Project	IEEE 802.16 Mobile Broadband Wireless Access Working Group < http://ieee802.org/16 >
Title	Flexible Data Encryption Location
Date Submitted	[2004-05-07]
Source(s)	Yong Chang Samsung Elec. 416, Maetan-3dong, Youngtong-gu Suwon-si, Gyeonggi-do Korea
Re:	Working Group Review of P802.16-REVe_D2
Abstract	Enhance the Privacy sublayer for P802.16-REVe_D2 to allow the flexible data encryption location
Purpose	Propose the text in Privacy sublayer for IEEE802.16REVe/D2-2004
Notice	This document has been prepared to assist IEEE 802.16. It is offered as a basis for discussion and is not binding on the contributing individual(s) or organization(s). The material in this document is subject to change in form and content after further study. The contributor(s) reserve(s) the right to add, amend or withdraw material contained herein.
Release	The contributor grants a free, irrevocable license to the IEEE to incorporate material contained in this contribution, and any modifications thereof, in the creation of an IEEE Standards publication; to copyright in the IEEE's name any IEEE Standards publication even though it may include portions of this contribution; and at the IEEE's sole discretion

Figure XXX. Construction of a MAC PDU

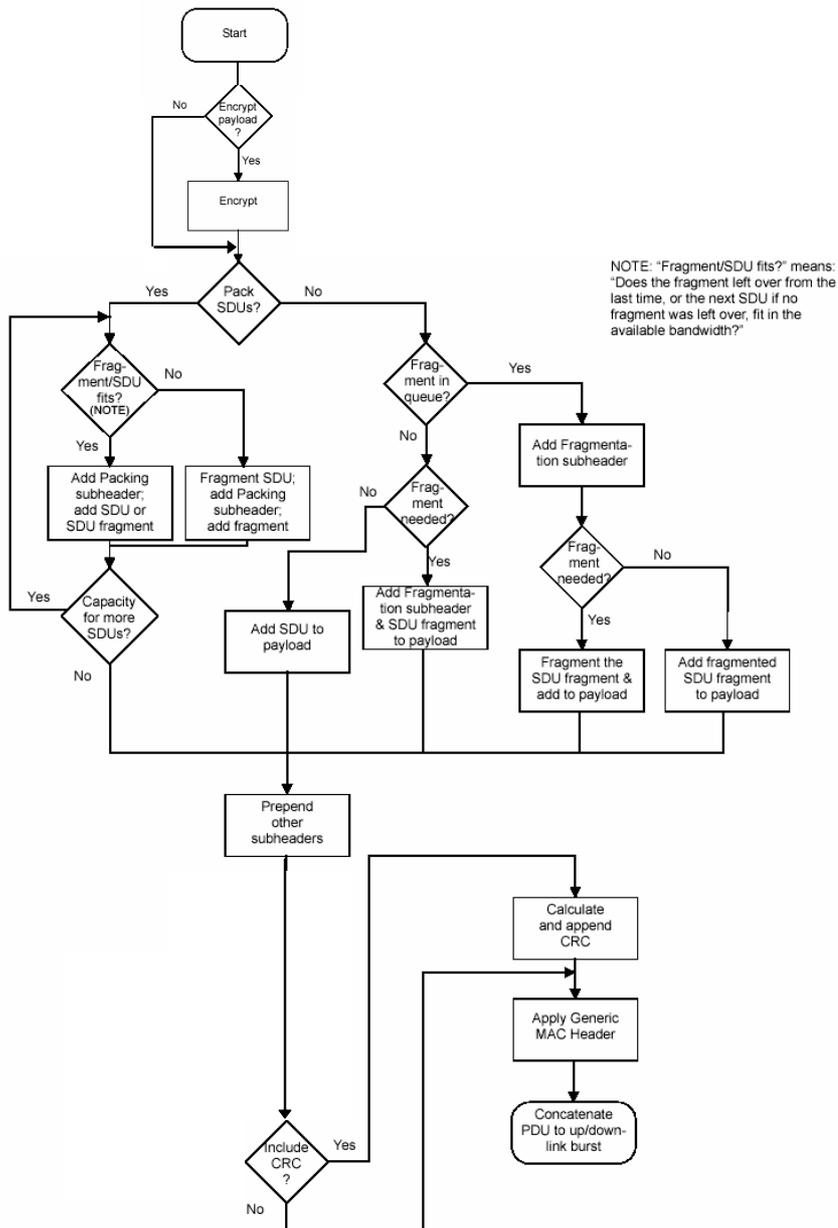
13 The construction of a MAC PDU is illustrated in Figure 26 or Figure XXX. The encryption payload may be performed
14 after or before the packing and the fragmentation.

Figure 32—MAC PDU encryption

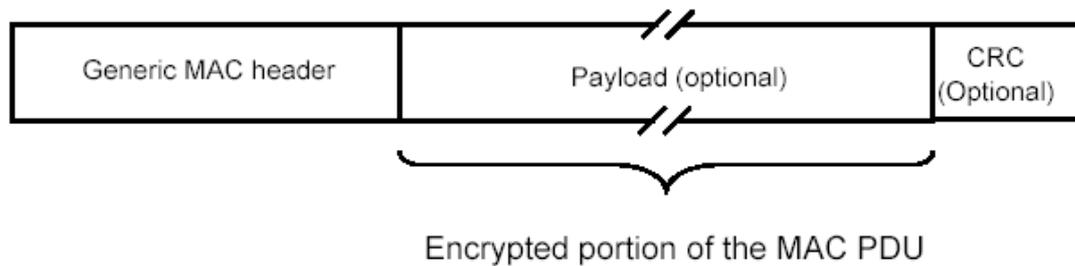
When transmitting a MAC PDU on a connection that is mapped to an SA, the sender shall perform encryption and data authentication of the MAC PDU payload or MAC SDU as specified by that SA. When receiving a MAC PDU on a

1 connection mapped to an SA, the receiver shall perform decryption and data authentication of the MAC PDU payload
 2 or MAC SDU, as specified by that SA.

3
 4 The generic MAC header shall not be encrypted. The MAC subheader may not be encrypted. The Header contains all
 5 the Encryption information [EC Field, encryption key sequence (EKS) Field, and CID] needed to decrypt a Payload or
 6 MAC SDU at the receiving station. This is illustrated in Figure 34.
